Shop Drawing Submittal Review

Project Name: Webster University-**ISB**

Copies	No.	Description
1 PDF	224216P02	(Submittal No.'s)
		(Cannon #22 4216.16-001) - (Paric #15051-) – (WES #607)
		➢ **Commercial Sinks**
		• Clinical Service Sink CSS-1
		• Scrub Sink SS-1
		• Sink SK-1
		• Garbage Disposer GD-1
		• Sink SK-2
		• Sink SK-3
		• Mop Sink MS-1
		• Kitchen Sinks KS-1, KS-2, KS-3

PROJECT NAME:	Webster University ISB
LOCATION:	St. Louis Missouri
CLIENT PROJ. NO.:	N/A
WES PROJ. NO.:	607
SPEC SECTION:	22 4216.16 Commercial Sinks
SUBMITTAL ITEM:	See Below -

SCR1B/ SCR09/ SCR19/ SCR39/ SCR49 Multi-Turn Angle Stop w/ Loose Key – Compression x Compression

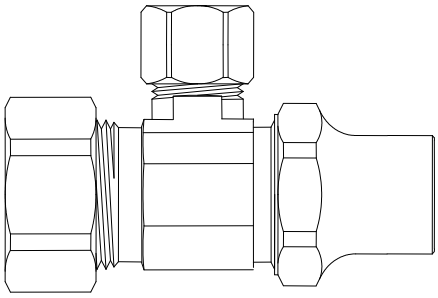
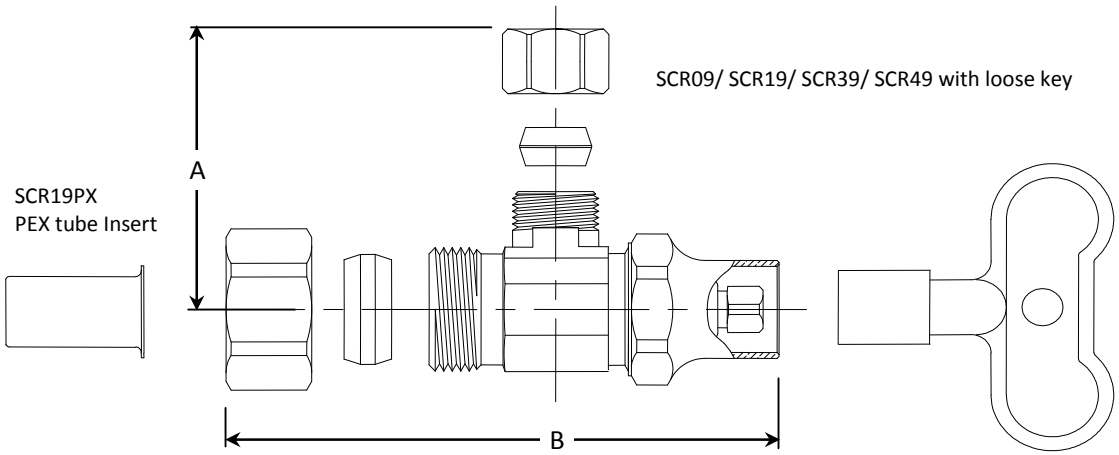
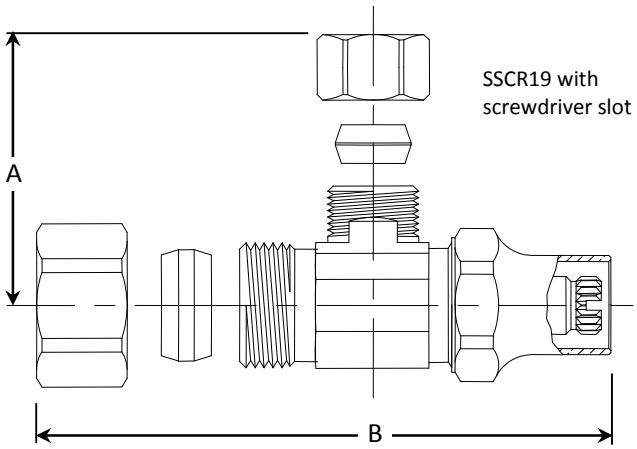
Escutcheons are specified to be cast brass. Refer to specification section 220518.
